Time to take a stand â?? the proposed new Ben More hydro track

On 7th July, an application for a new hydro scheme on the slopes of Ben More by Crianlarich, one of the highest and best known Munros, was validated on the Loch Lomond and Trossachs Planning Portal ([see here](#)) (or if the link does not work go to <http://www.lochlomond-trossachs.org/planning/planning-applications/find-an-application/> and search for application Ref 2017/0119/DET or on Benmore farm). On Friday I went to have a look and have now submitted an objection to the application as currently proposed (appended to end of this post). This post is about

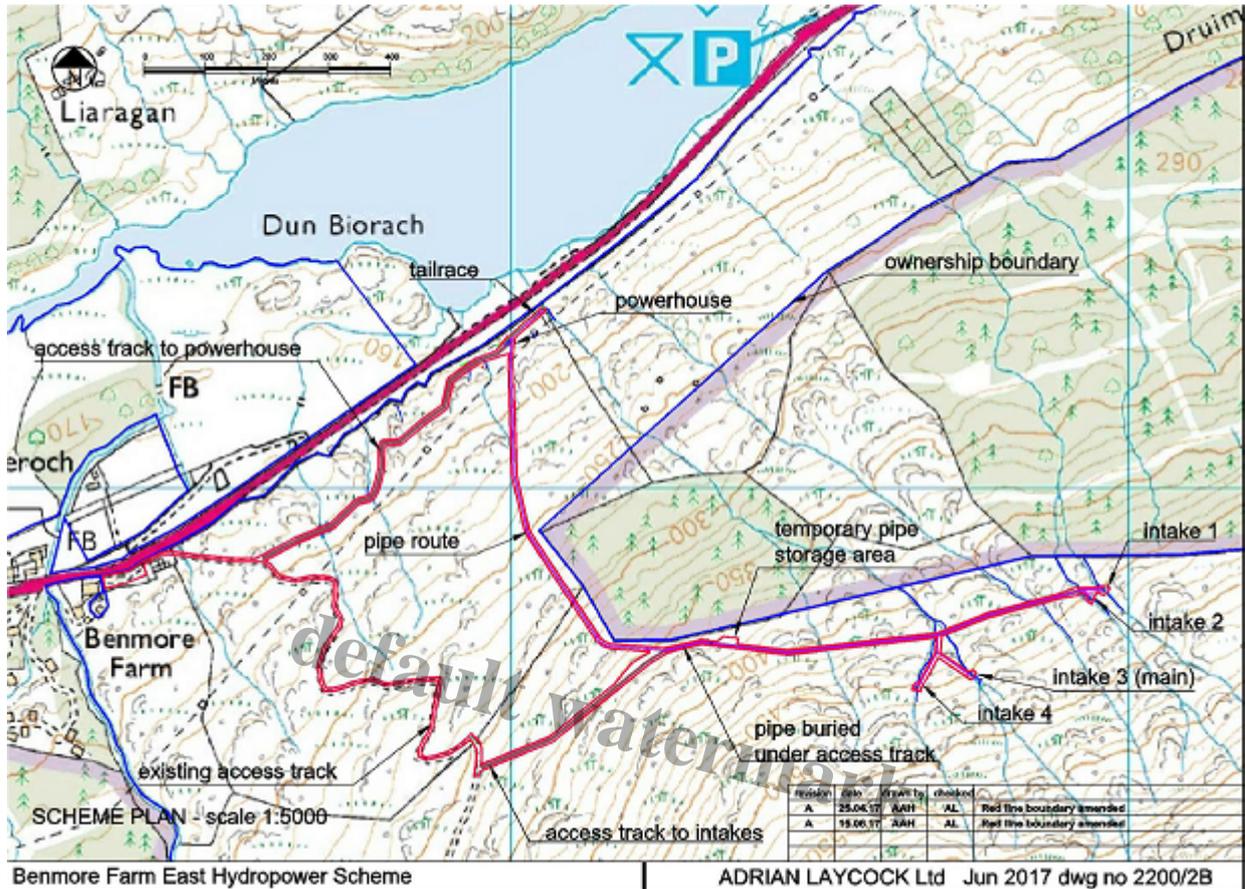
When you approach the intake though the most obvious feature is the metal fencing â?? contrary to Park guidance on use of natural materials (but is it really necessary?) â?? and the Lomond blue pipe. Its a shame that the left side of the intake has not been finished like the right had side but it does show, I think, what can be done. Well done somebody!

The recovery of the ground above the pipeline and construction track is not as good as it might have been because vehicles have been driven over land which is far too wet to support them.

Part of the Allt Essan hydro scheme on the north side of Glen Dochart – power house centre

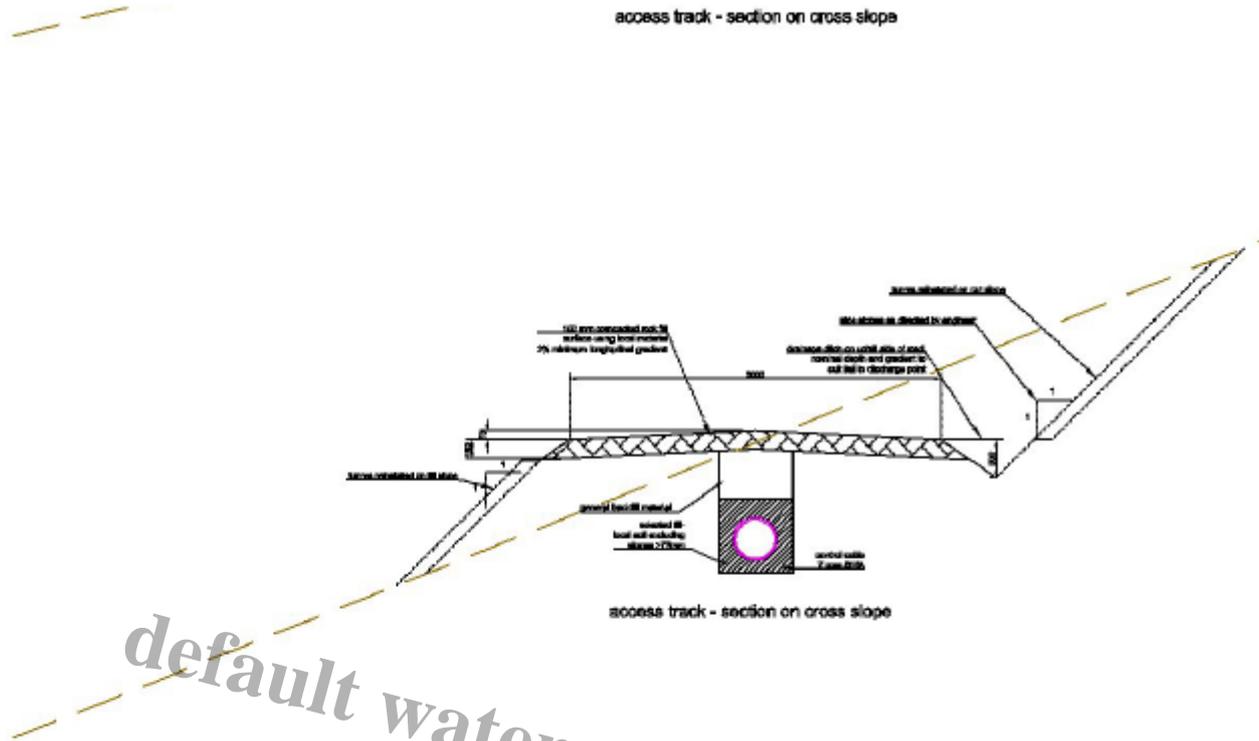
What prompted me to visit the location the scheme was the proposal to retain the new access tracks. Having removed the construction tracks to the intake in the Benmore Burn scheme, I wanted to understand why Benmore Farm were proposing to retain the construction tracks to the new intakes. Part of me reckons that this is because since 2013, when the first scheme was approved, the LLTNPA as Planning Authority have moved from a position of assuming tracks should be removed to allowing them to remain everywhere.

So, if other people are getting away with it, why should Benmore Farm follow best practice? That's why people need to take a stand. The proliferation of hill tracks is destroying the landscape in the National Park and indeed across Scotland and those who care about the landscape need to put a stop to this.
